**DEVIATION REQUEST** (Attach diagrams, figures, and other documentation to clarify request)

To permit a right-in/right-out access from Fontaine Boulevard into the Lorson Ranch Commercial parcel.

# LORSON RANCH COMMERCIAL CONCEPT DRAWING

EL PASO COUNTY, COLORADO  
JUNE 03, 2022

CONCEPT  
DRAWING

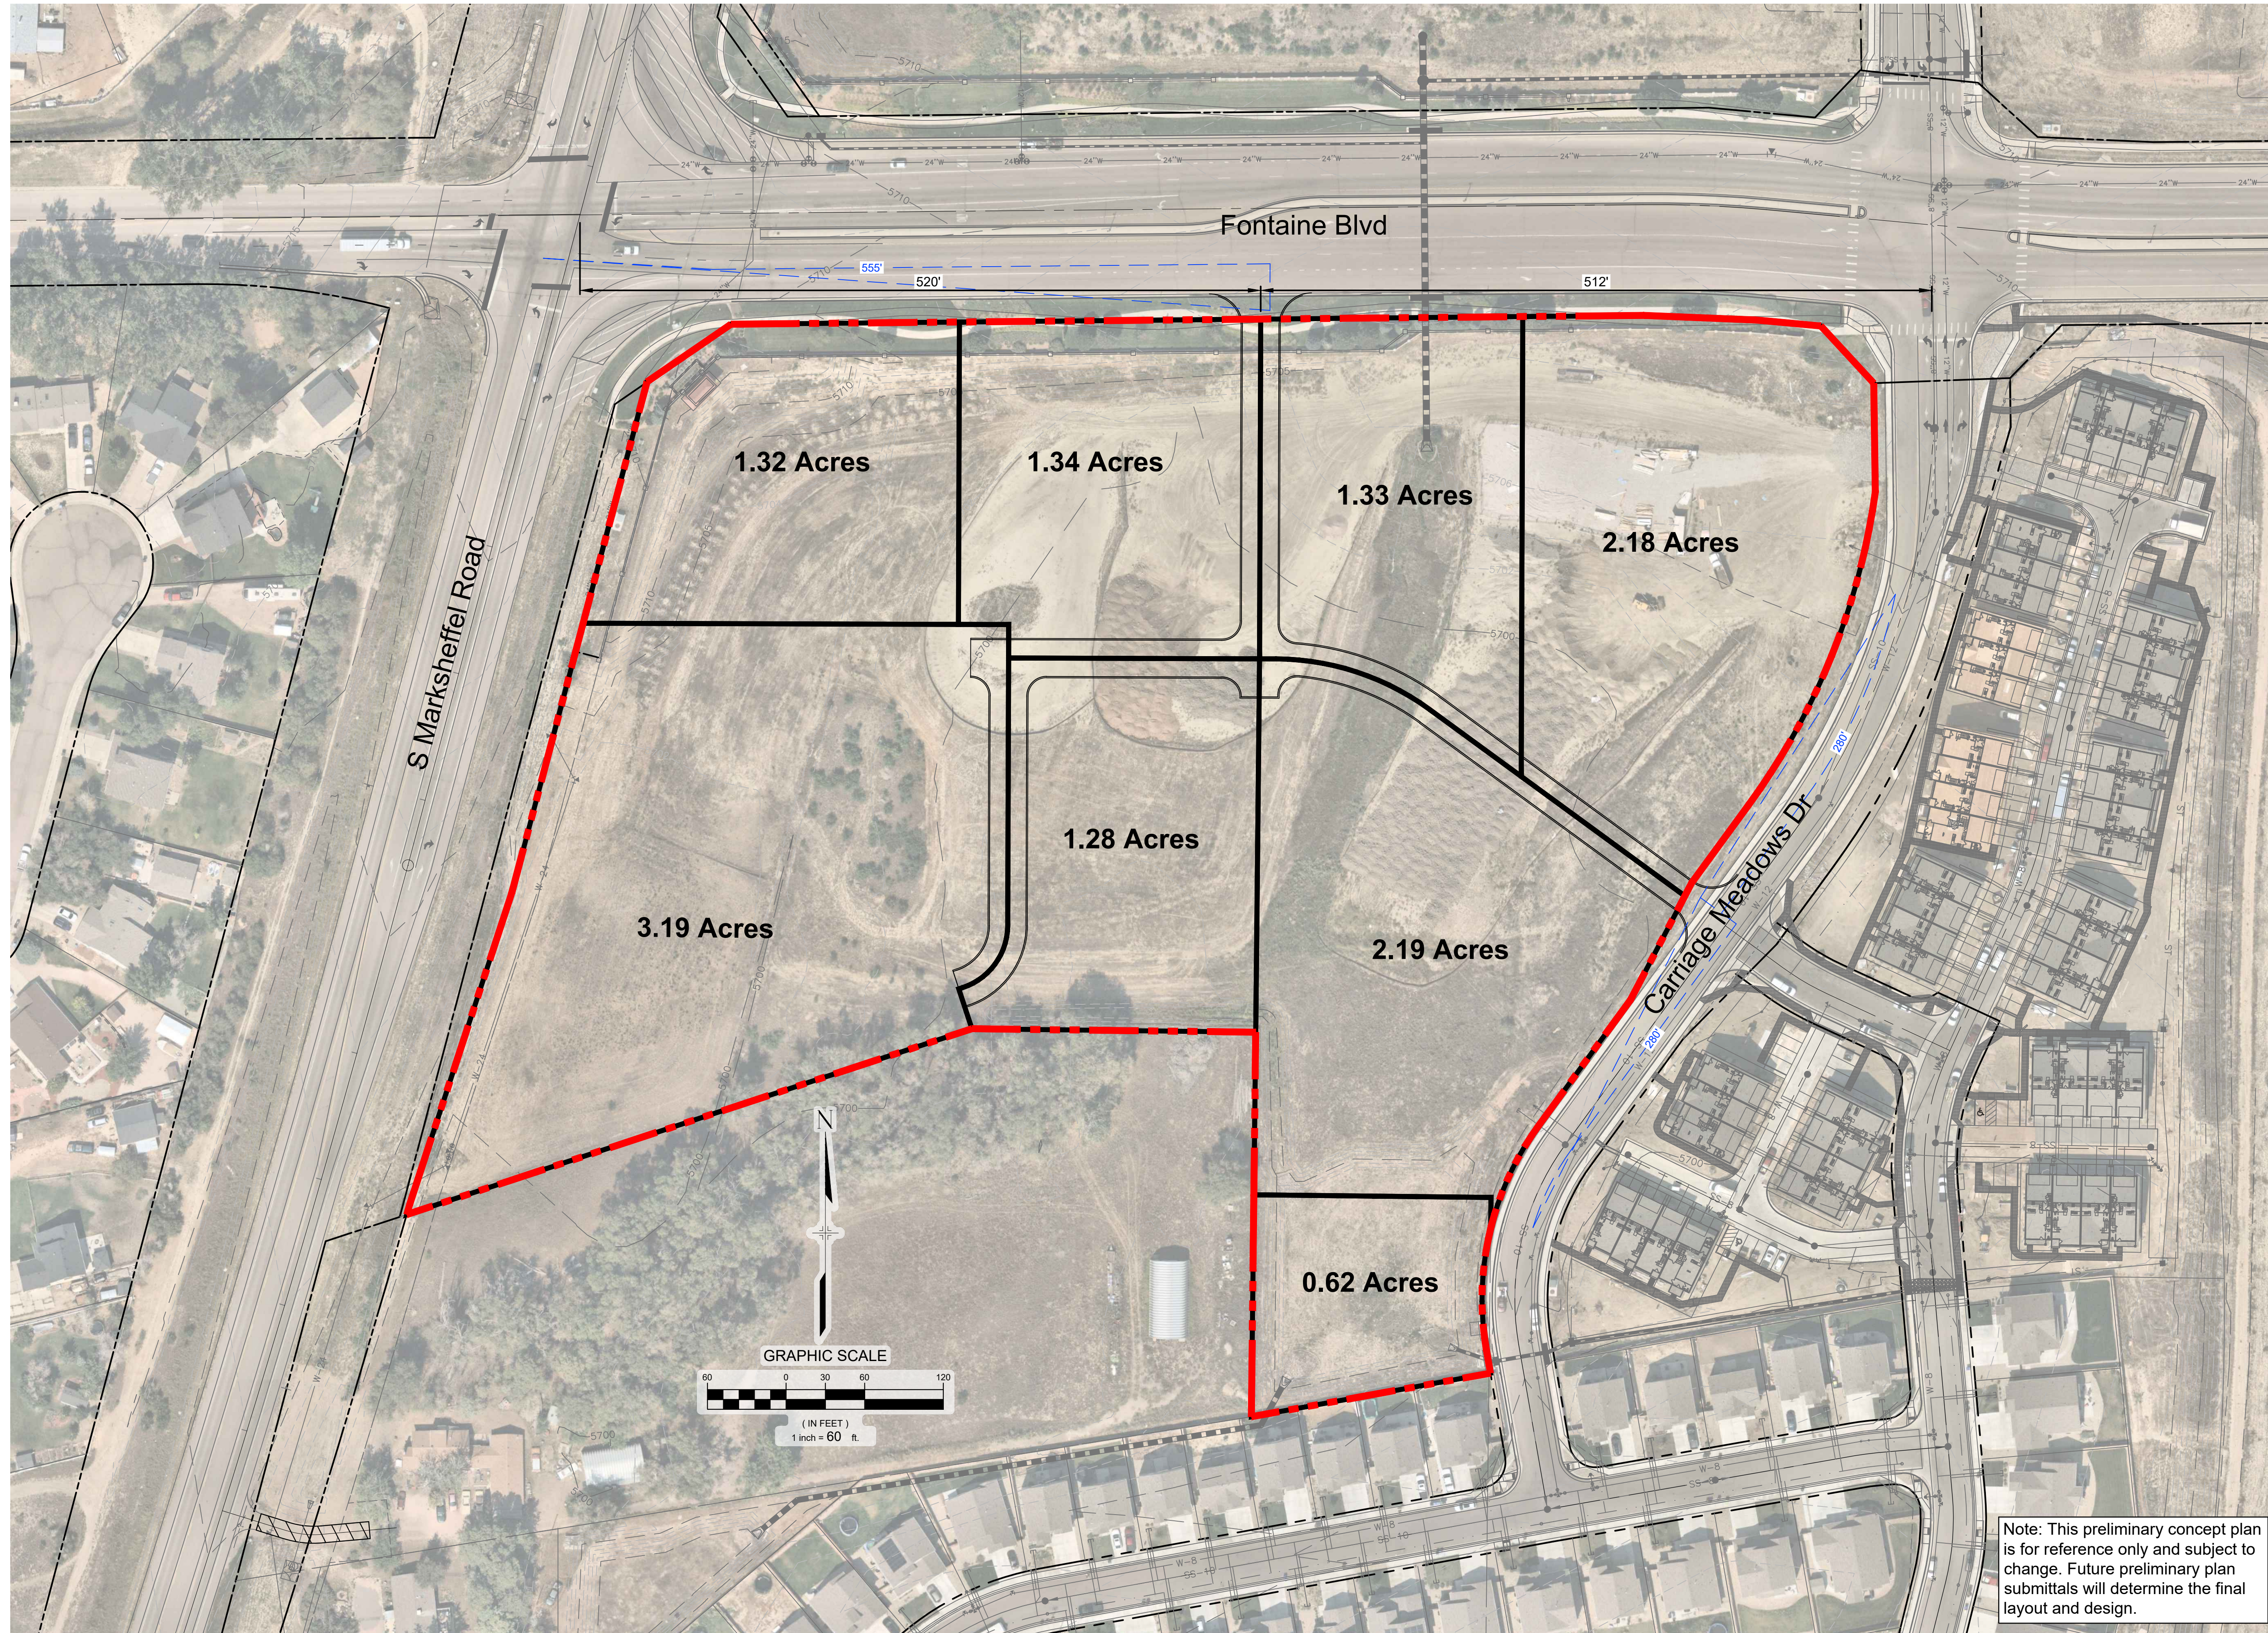
The proposed alternative to the ECM standard is requested because of a desire by the owner/ developer to provide a more direct and secondary access point into the Lorson Ranch Commercial parcel and reduce the amount of commercial traffic using Carriage Meadows Drive (collector).

The deviation will help reduce the amount of commercial traffic on Carriage Meadows Drive. Additionally, the right-in/right-out access point is half-way (approximately 520' feet) between the intersections of Marksheffel Road and Carriage Meadows Drive. All of the turn movements will take place in an existing auxiliary lane where speeds are already reduced and nowhere near the design speeds of Fontaine Boulevard.

The deviation will achieve the intended result with a comparable or superior design and quality of improvement. The deviation will help reduce the amount of commercial traffic on Carriage Meadows Drive. Additionally, the right-in/right-out access point is half-way (approximately 520' feet) between the intersections of Marksheffel Road and Carriage Meadows Drive. The required entering sight distance of driveways for passenger cars and pickup trucks is 540' on a four-lane roadway at 45 mph. All of the turn movements will take place in an existing auxiliary lane where speeds are already reduced and nowhere near the design speeds of Fontaine Boulevard. The entering site distance is reduced to 420' at 35 mph therefore the entering site distance of approximately 520' should be sufficient . The proposed right-in/right-out will not impair the auxiliary lane design onto Carriage Meadows Drive.

The deviation will not adversely affect safety or operations. The deviation will help reduce the amount of commercial traffic on Carriage Meadows Drive. Additionally, the right-in/right-out access point is half-way (approximately 520' feet) between the intersections of Marksheffel Road and Carriage Meadows Drive. All of the turn movements will take place in an existing auxiliary lane where speeds are already reduced and nowhere near the design speeds of Fontaine Boulevard. An additional pedestrian crossing will be required along the south side of Fontaine Boulevard at the proposed right-in/right-out driveway. Appropriate pedestrian safety including adequate entering sight distance will be accommodated. The turn lane for Carriage Meadows Drive will function appropriately and will not create public safety issues.

The deviation will meet the design intent and purpose of the ECM as the additional right-in/right-out access provides adequate intersection sight distance clearance of approximately 520'. The right-in/right-out is centered between Marksheffel Drive and Carriage Meadows Drive and will not create sight distance issues at either intersection. The required entering sight distance of driveways for passenger cars and pickup trucks is 540' on a four-lane roadway at 45 mph. All of the turn movements will take place in an existing auxiliary lane where speeds are already reduced and nowhere near the design speeds of Fontaine Boulevard. The entering site distance is reduced to 420' at 35 mph therefore the entering site distance of approximately 520' should be sufficient. The proposed right-in/right-out will not impair the auxiliary lane design onto Carriage Meadows Drive.
